**Lansing School District  
North Elementary Interior Renovations Bid Package 1**

**Addendum 01**

**January 13, 2026**

1 FIRST FLOOR PLAN

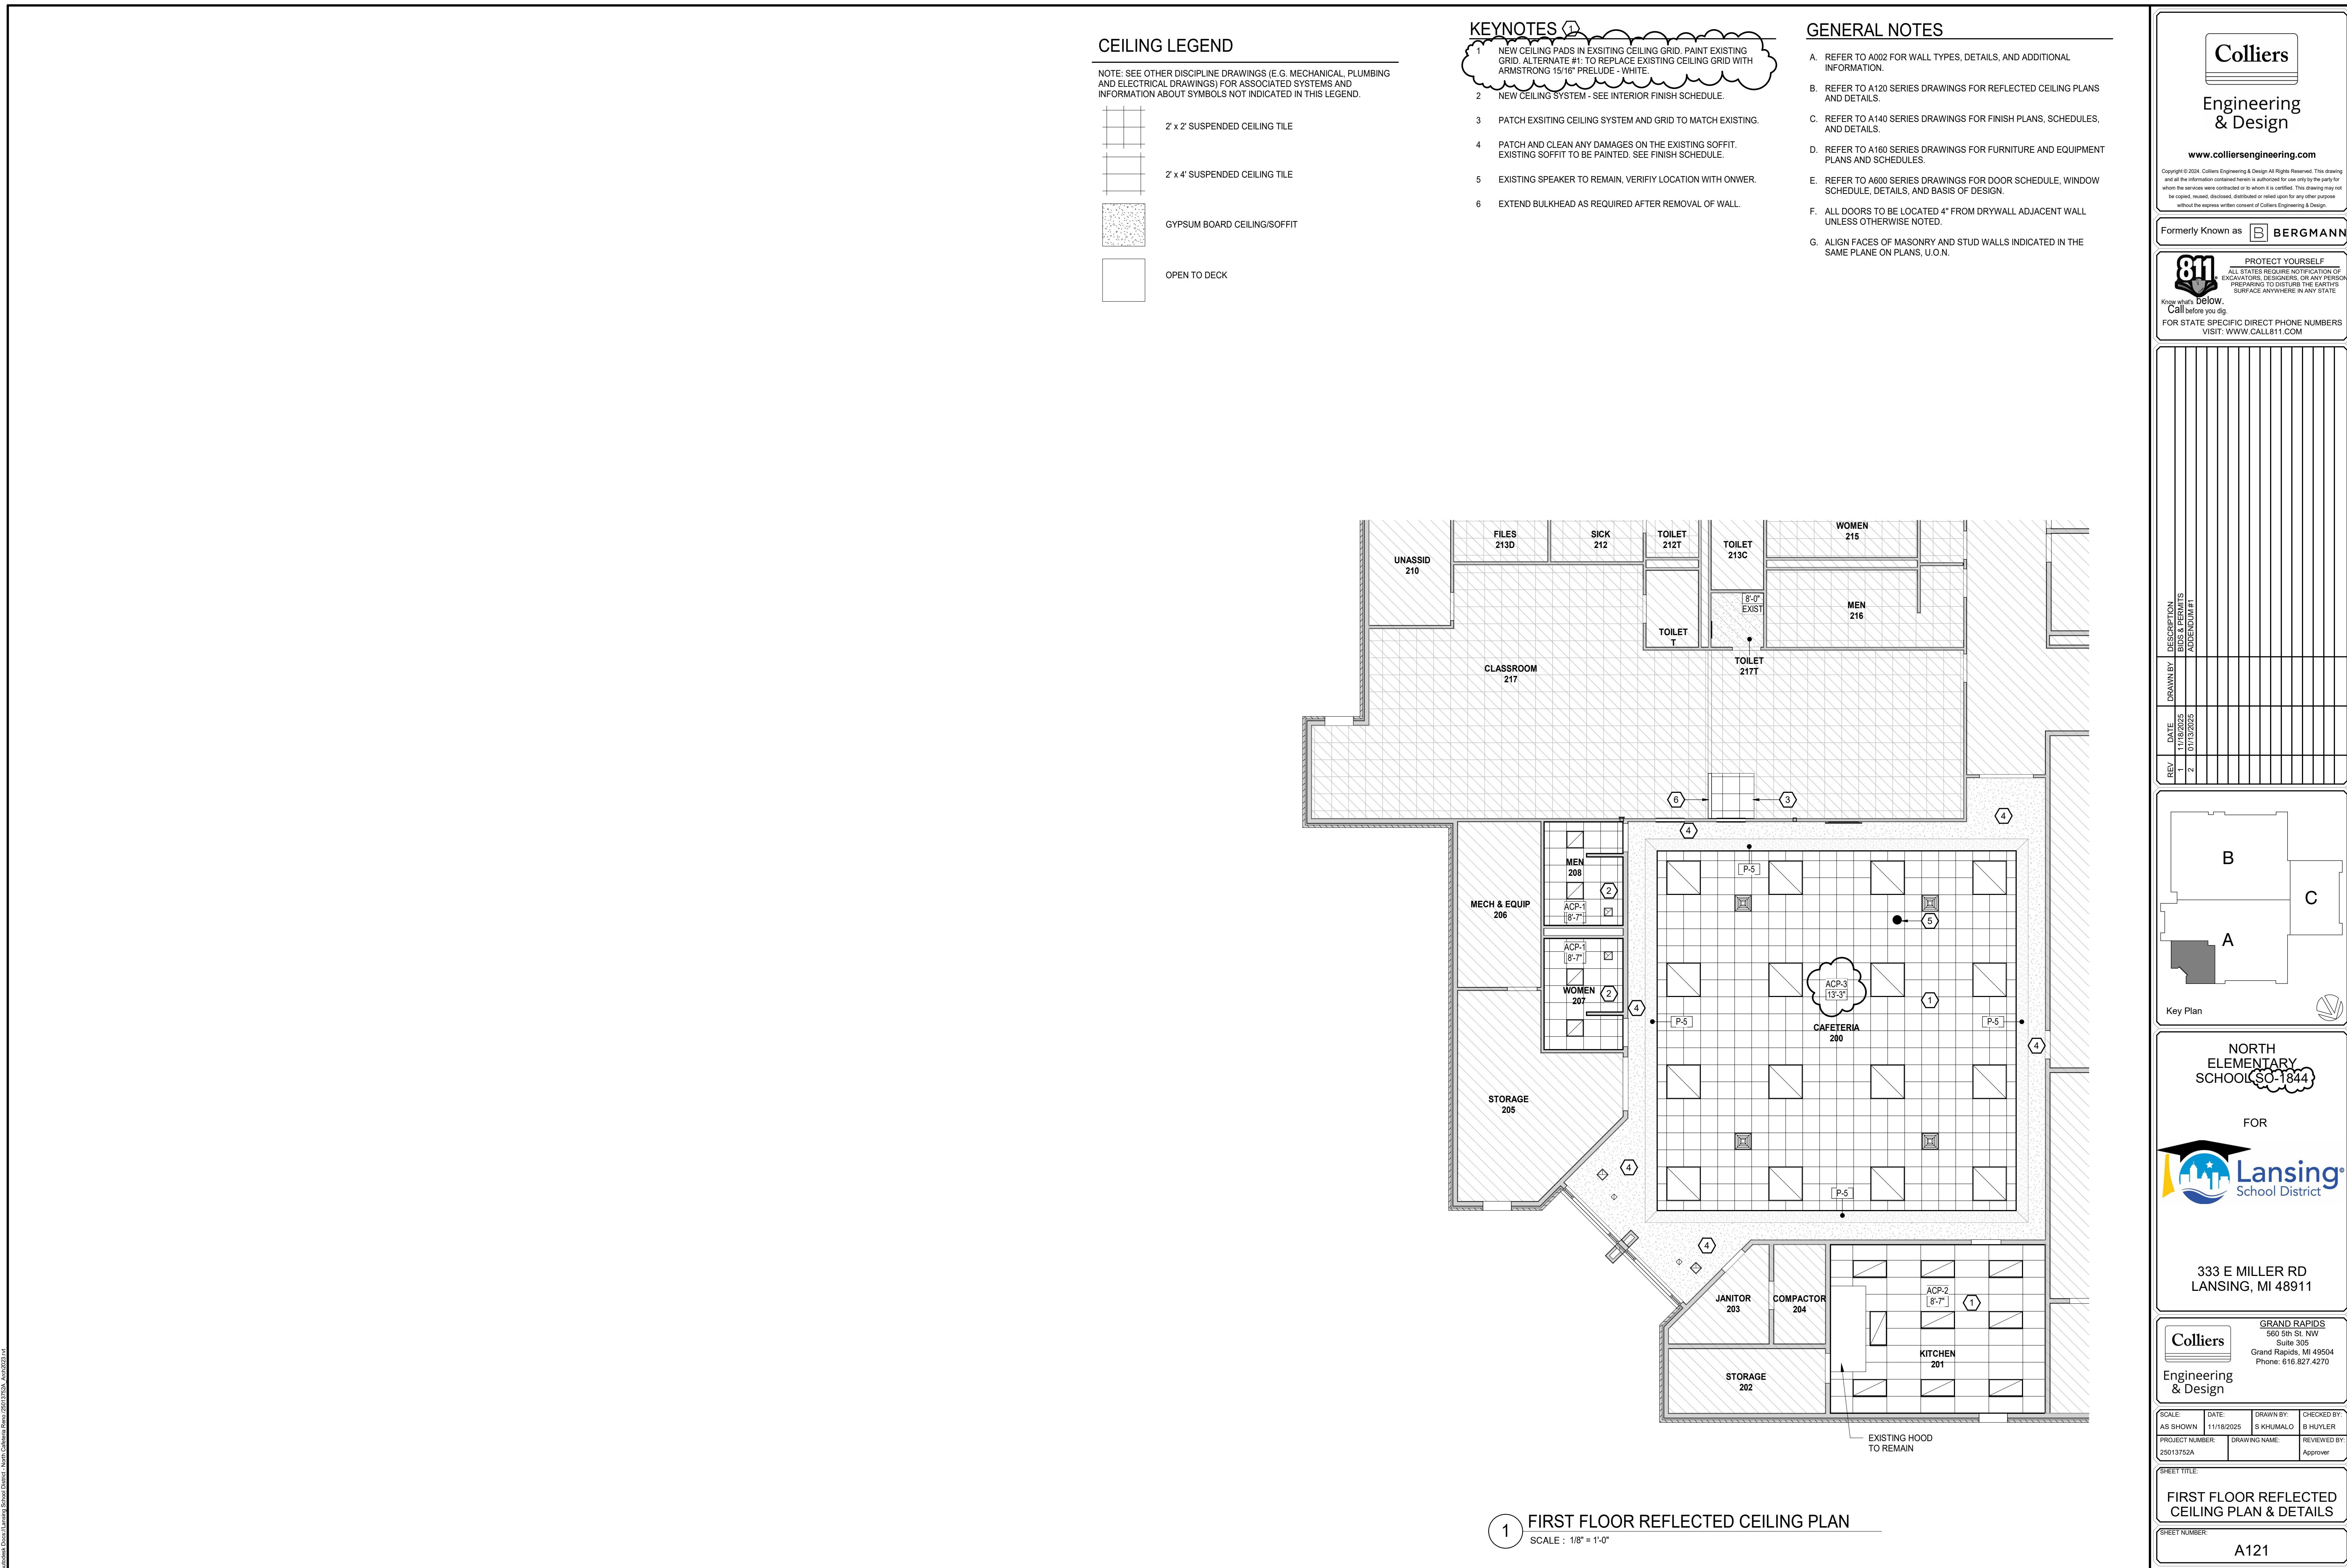
- Revised SO number in the title block.
  - Removed abatement note from cafeteria 200 as abatement has already been completed.
  - Removed door into classroom 217 and added keynote 8.

**FLOOR PLAN - PLUMBING**

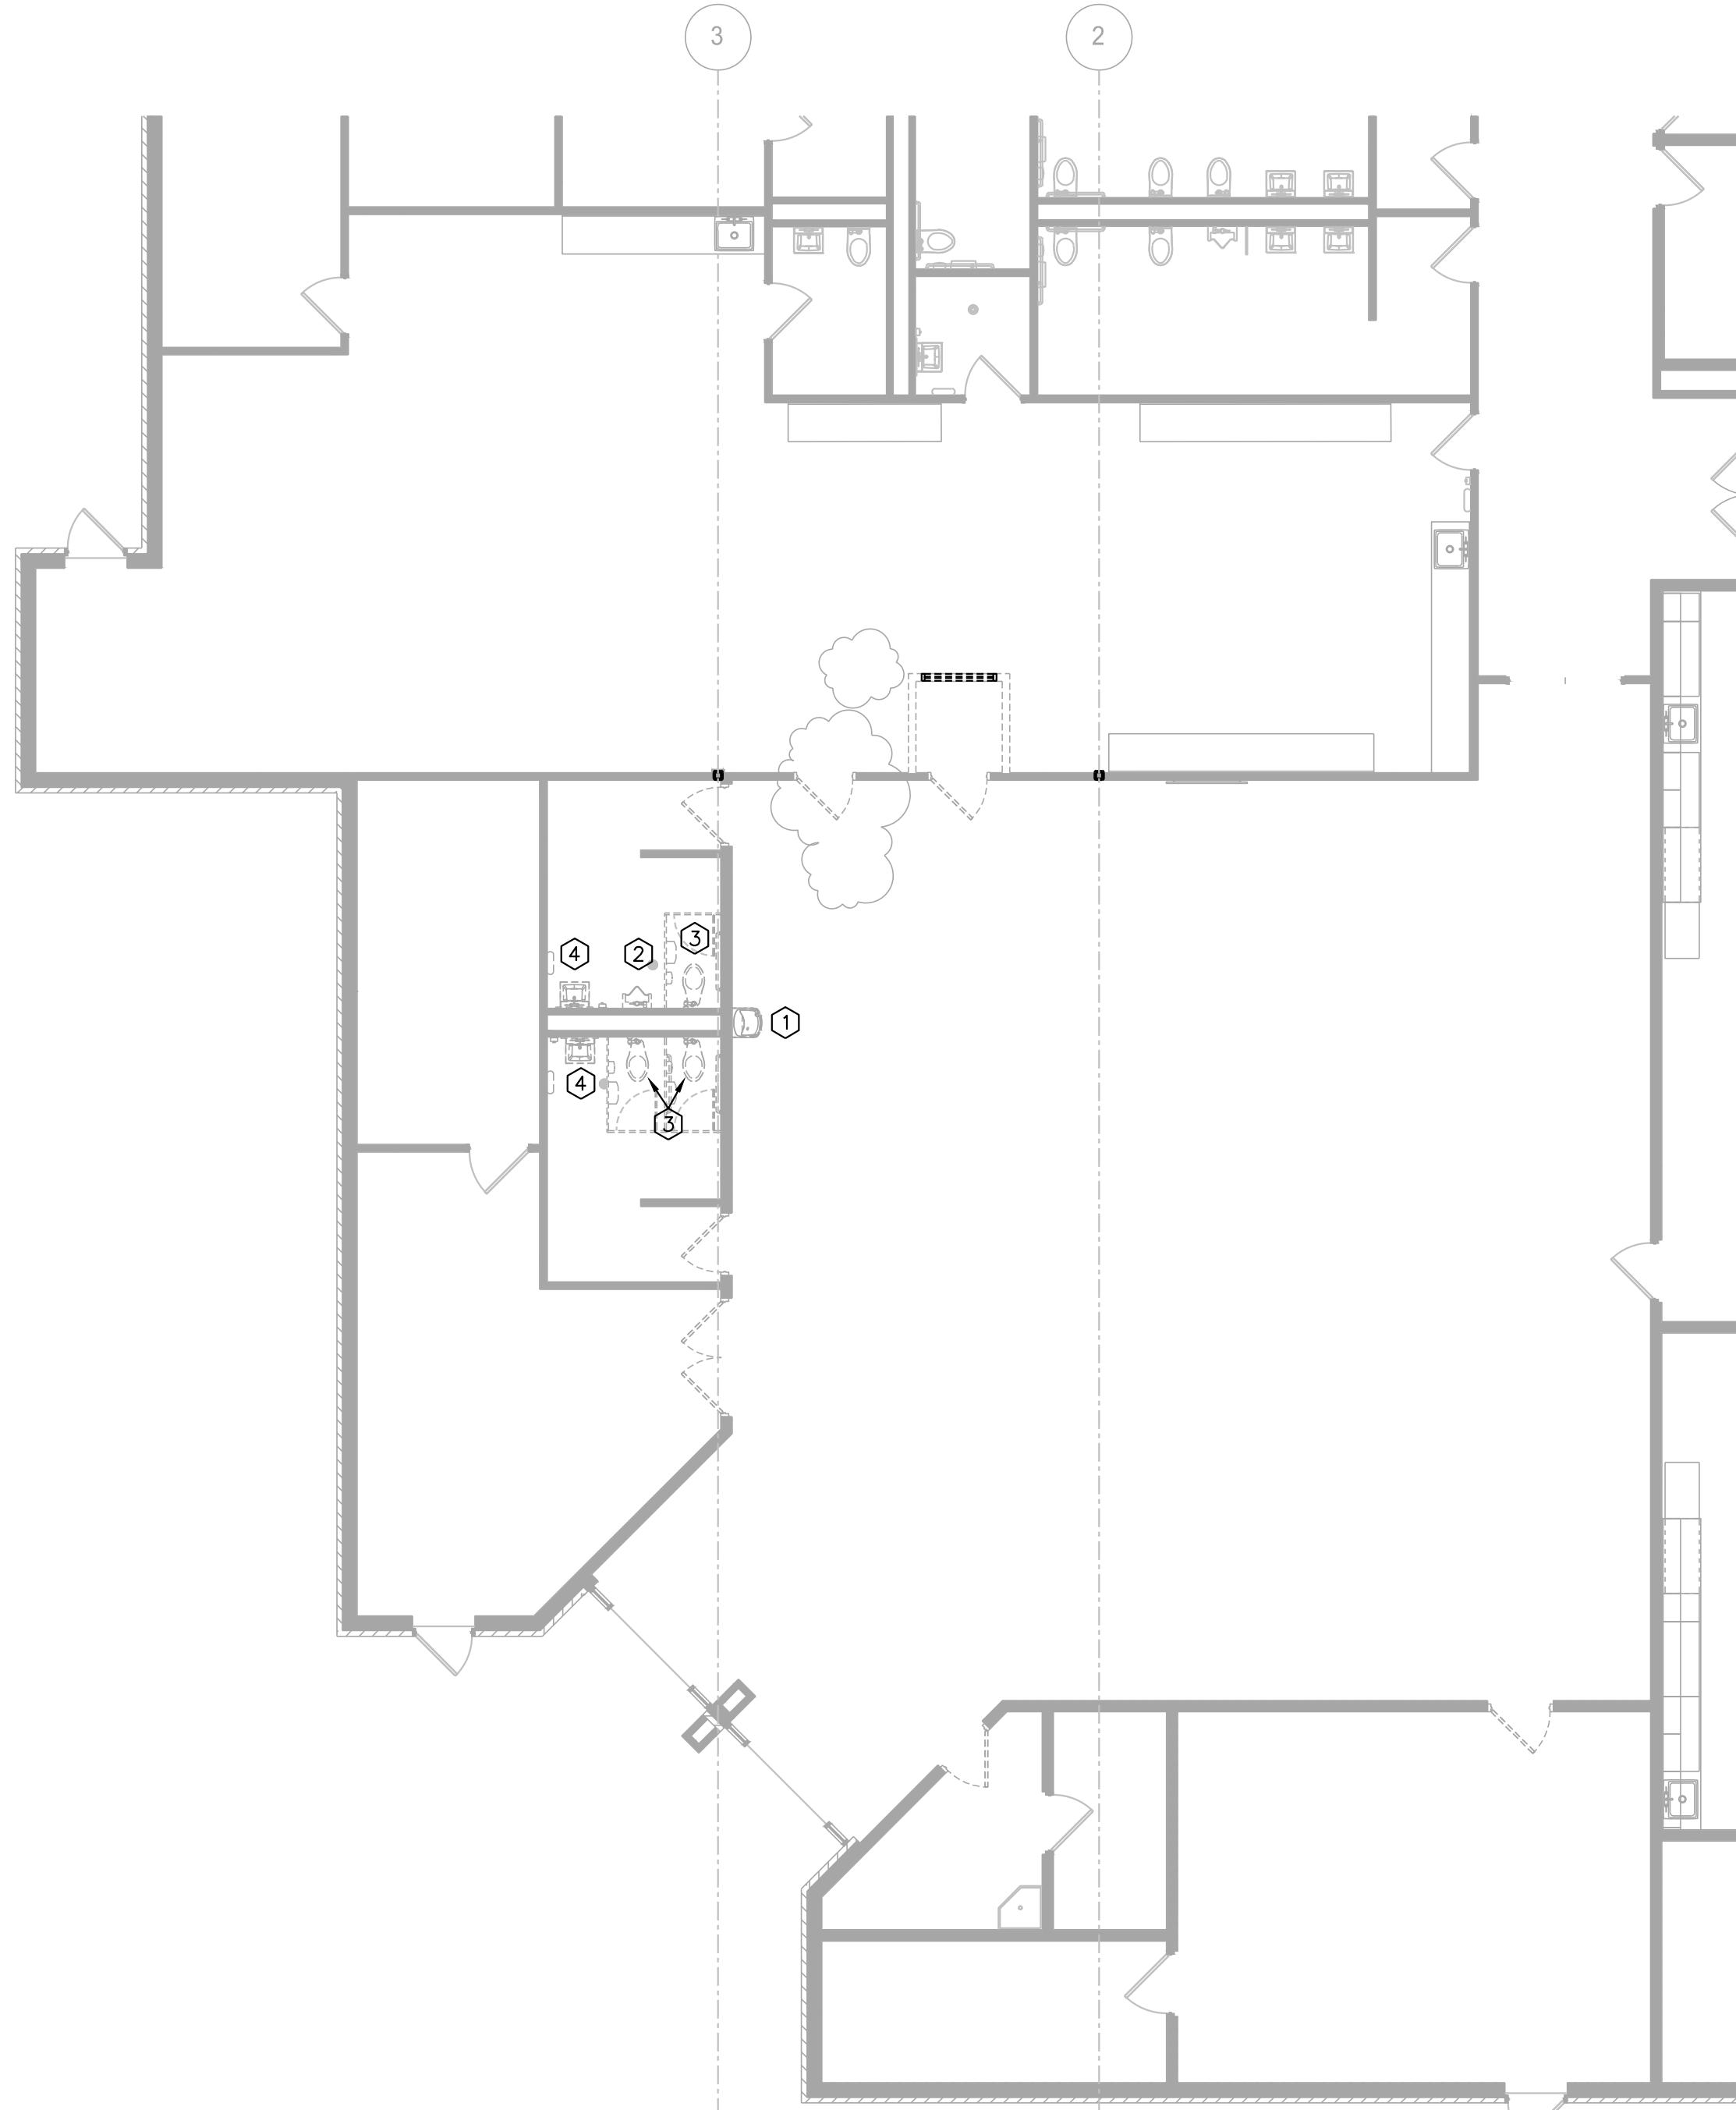
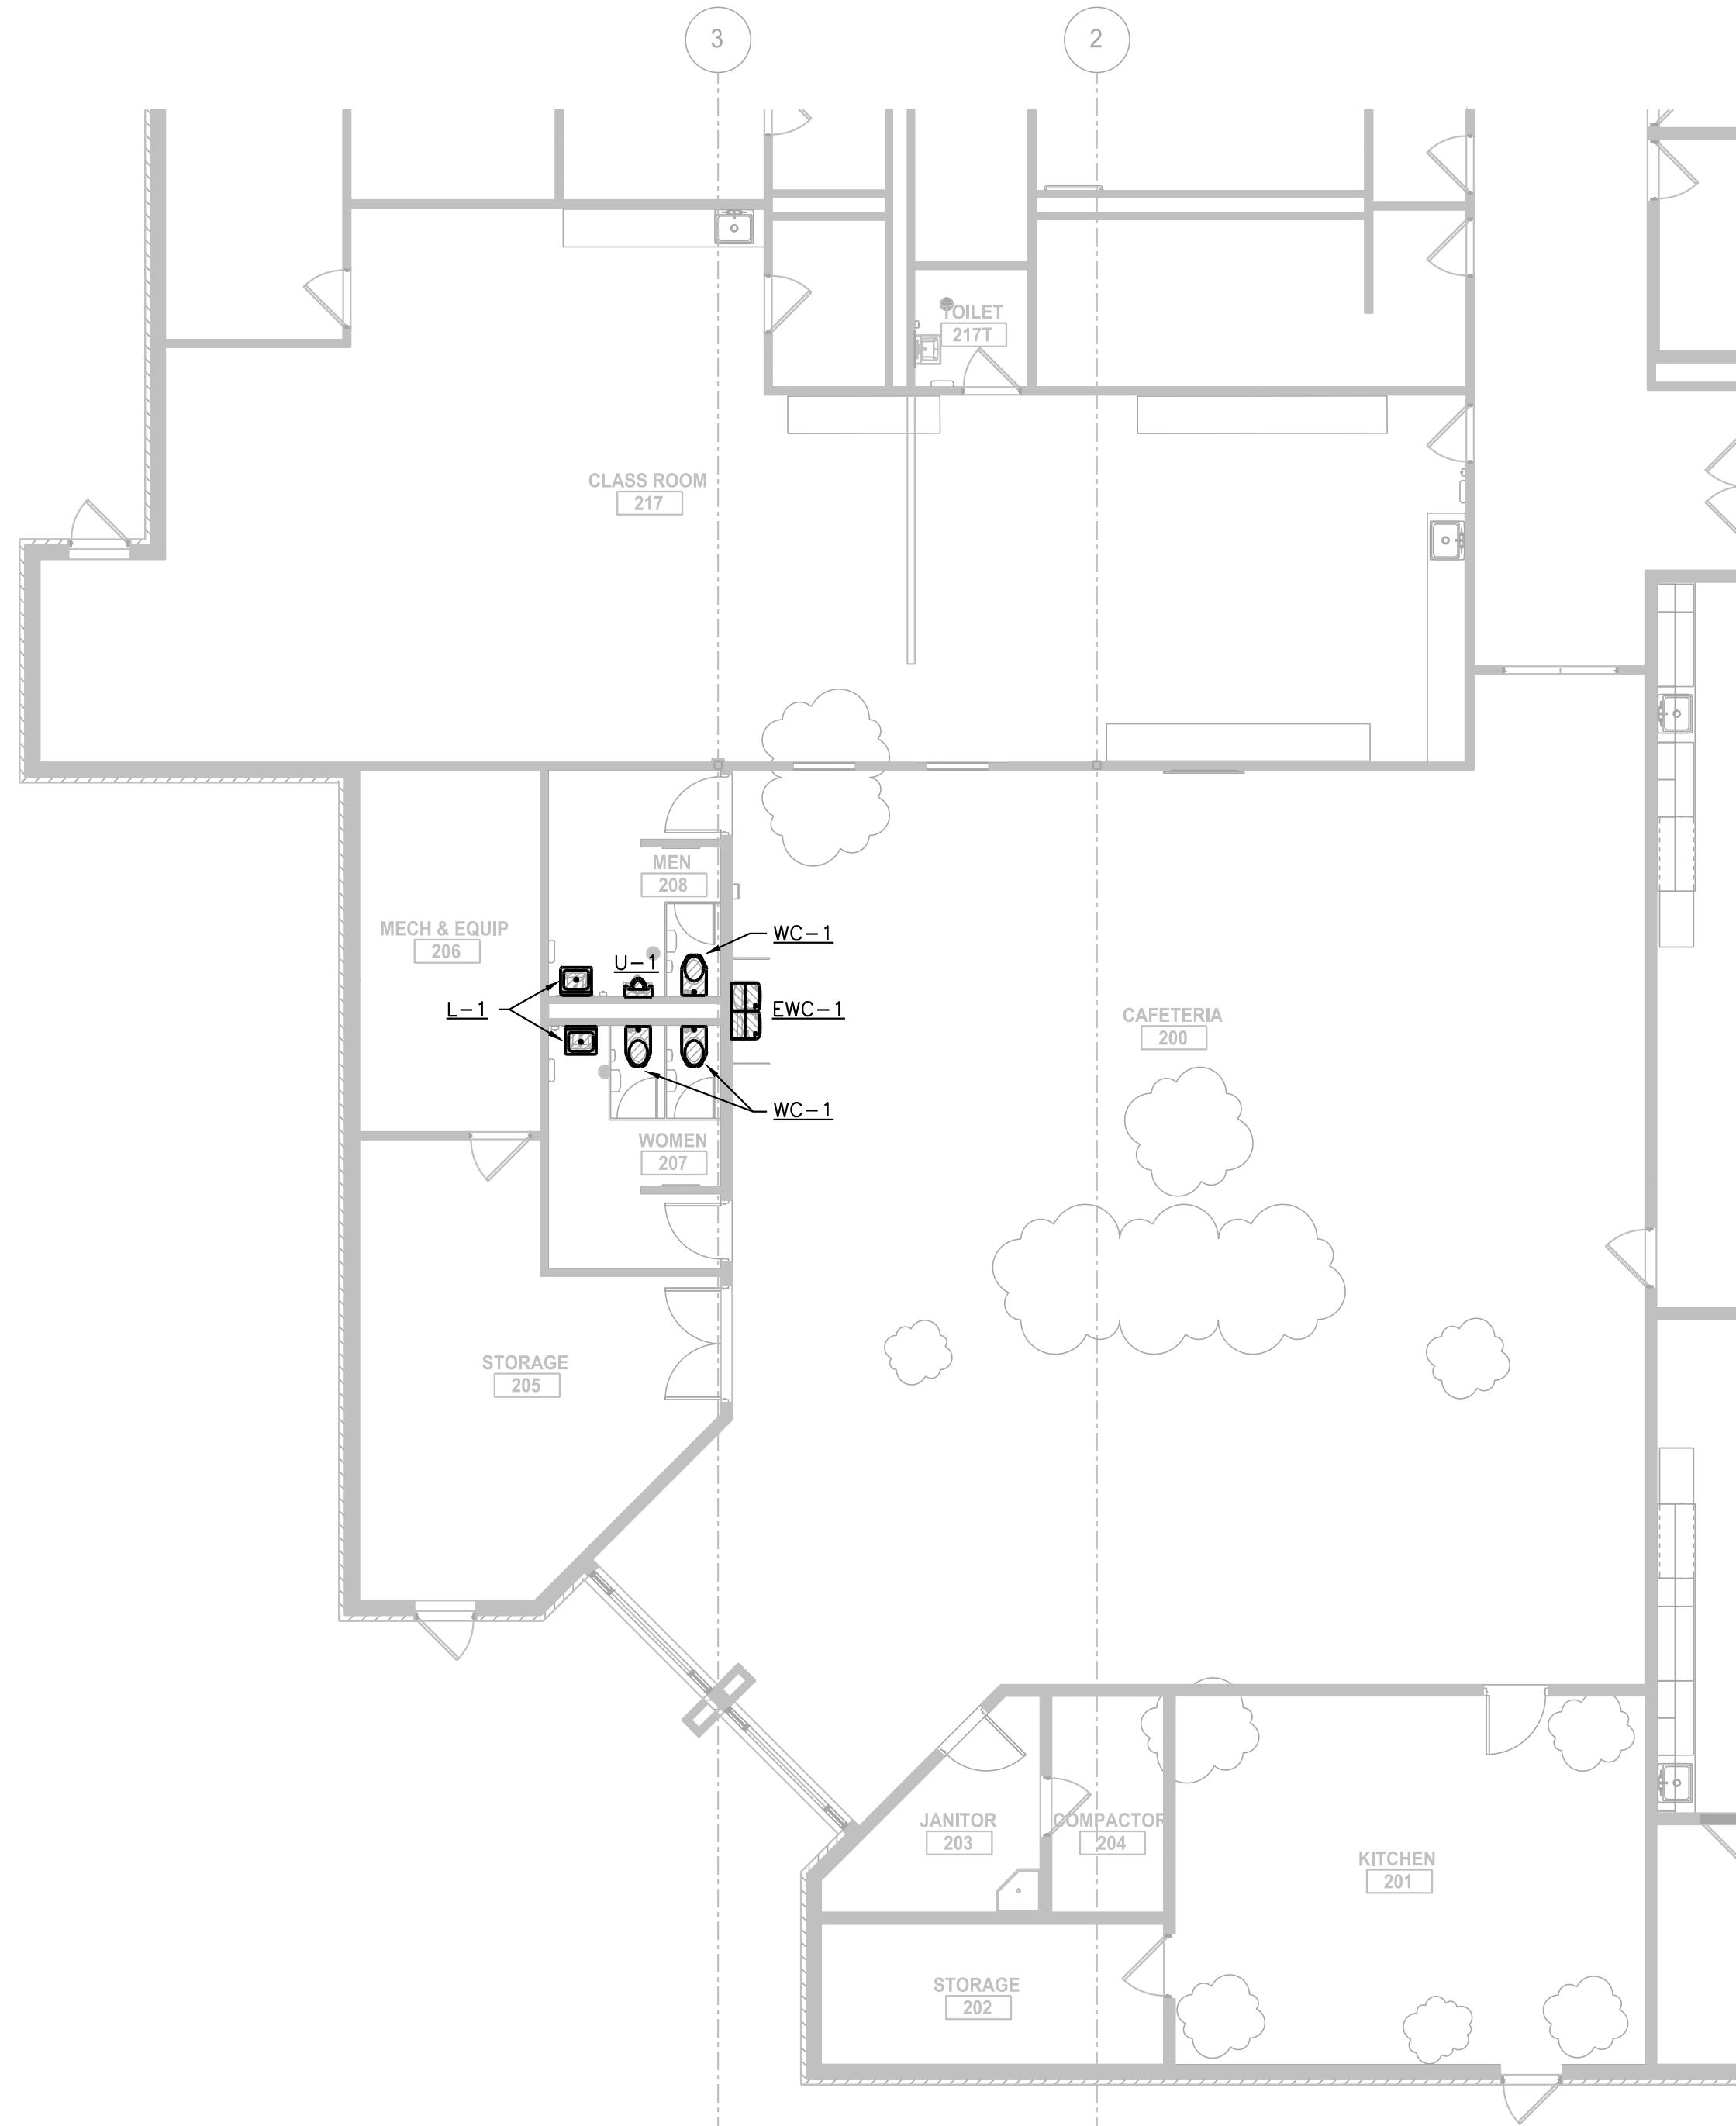
- **Plumbing Fixture list**
  - Specified product: Plumbing Fixtures U-1, WC-1, L-1
  - Substitution: Zurn Finish Plumbing Fixtures
  - Reason: Alternate manufacturer providing equal quality products
  - Differences: none
  - Decision: **Acceptable**

Section No.	Paragraph	Specified Product
	<u>Plan P101</u>	<u>Plumbing Fixture List</u>

Requesting Zurn be considered equal to the specified fixtures on Plan Page P101

- Plumbing Fixtures
  - *Specified Product:* Kohler Plumbing Fixtures
  - *Substitution:* Zurn Plumbing Fixtures
  - *Reason:* Requesting Zurn to be considered equal to the specified fixtures on Plan Page P101.
  - *Decision:* **Acceptable**
